PLANNING, ZONING, & BUILDING DEPARTMENT  
PZ&B Staff Combination Memorandum: Architectural Commission and Town Council

SUBJECT: ARC-23-052 (ZON-23-092) 300 COLONIAL LN (COMBO)

MEETING: JANUARY 24, 2024 ARCOM  
FEBRUARY 14, 2024 TC

CURRENT PROPOSED NORTH COLORED ELEVATION

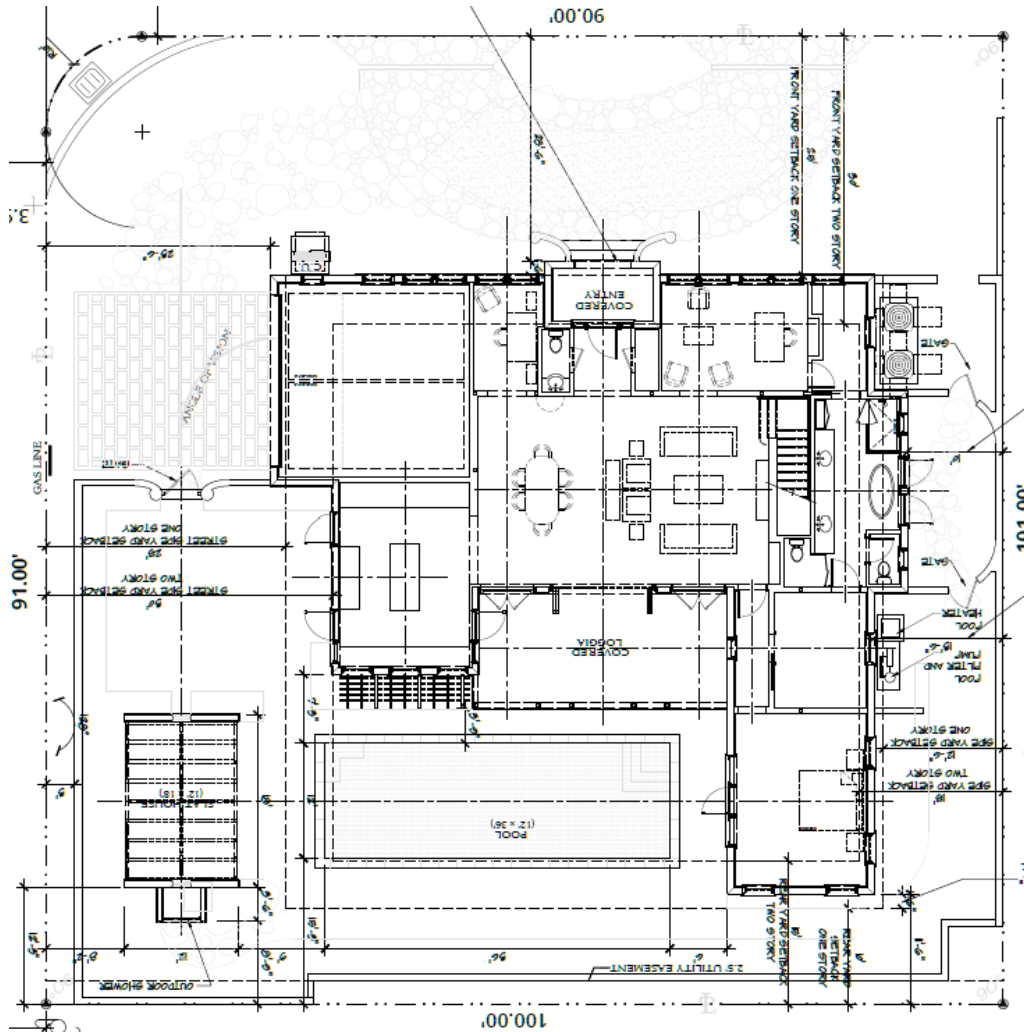
In response to commission comments, slight adjustments were made to the design which include reducing the overall building height by 10 inches, revising all roof pitches, eliminating the previously proposed chimney, removal a piece of A/C equipment from the east side yard (eliminates need for equipment variance in east side yard), removal of the trellis roof over the outdoor shower (eliminates need for a south rear yard setback variance), and reduction of rear loggia height and increase in loggia column size.

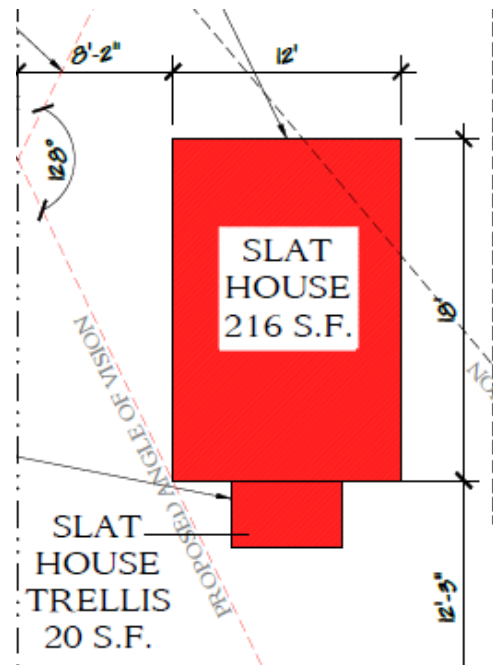
As the diagram to the right illustrates, **Variance numbers 2** through **4** occur at the accessory slat house structure.

At the west street-side yard setback, an 8.2' setback is proposed where a 25' street side-yard setback is required (Variance 2). Due to the slat house structure's proximity to the primary structure (less than 25'), it must be included in the angle of vision calculation, pushing the angle of vision to 128° where 100° is the maximum permitted (Variance 3).

The slat house structure also pushes the lot coverage percentage over the maximum permitted (lot coverage variance not required due to size of primary structure) with 32% lot coverage proposed with 30% maximum permitted (Variance 4).

*Highlighted areas in left diagram indicate 1st and 2nd floor setback variance requests in elevation. On left, the portions of the building shaded red indicate variance requests in plan view.*

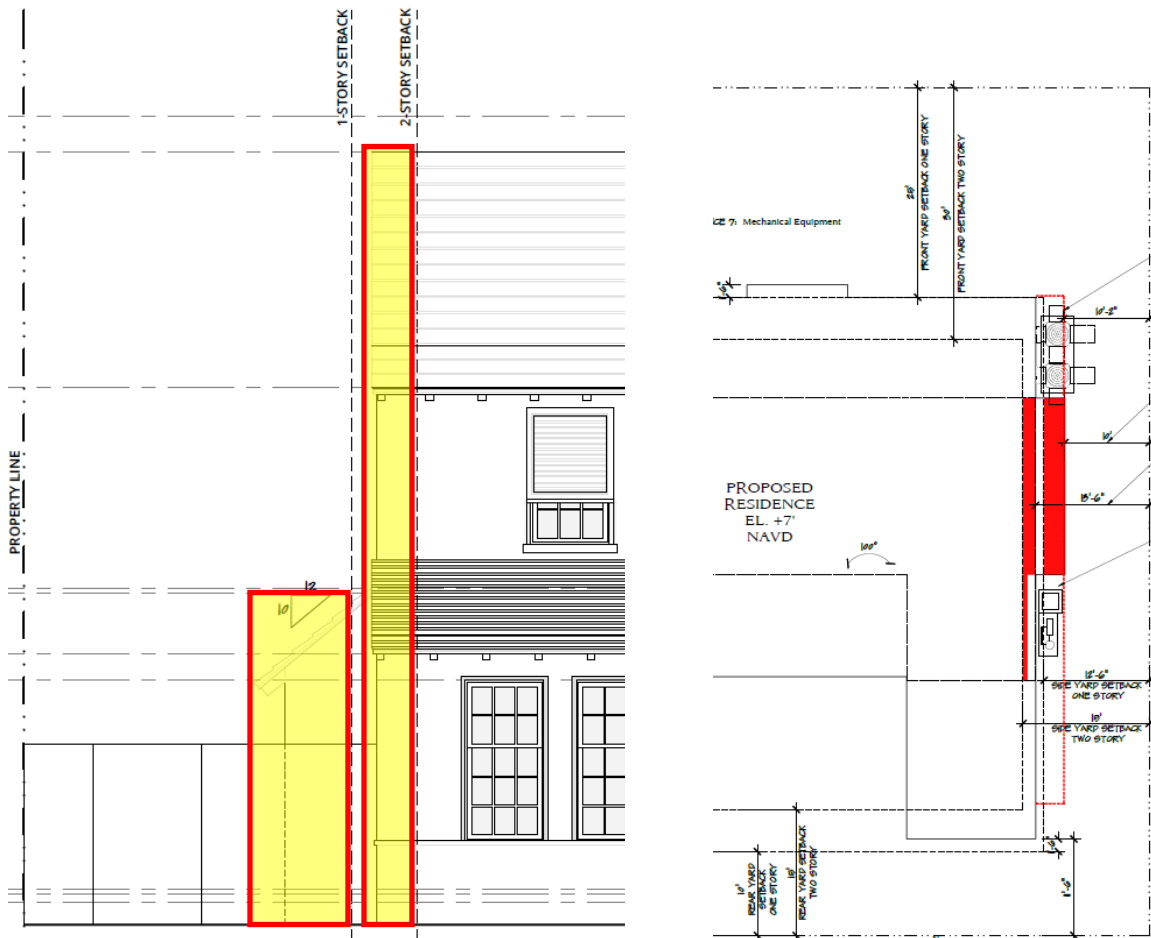
As the diagrams below indicate, variances **5** and **6** are required due to project features at the east side yard area.

The primary structure is proposed to have a first-story east side-yard setback of 10' where 12.5' is the minimum setback required.

At the second story, the two-story side-yard setback is proposed at 13.5' where 15' is the minimum two-story side-yard setback required.
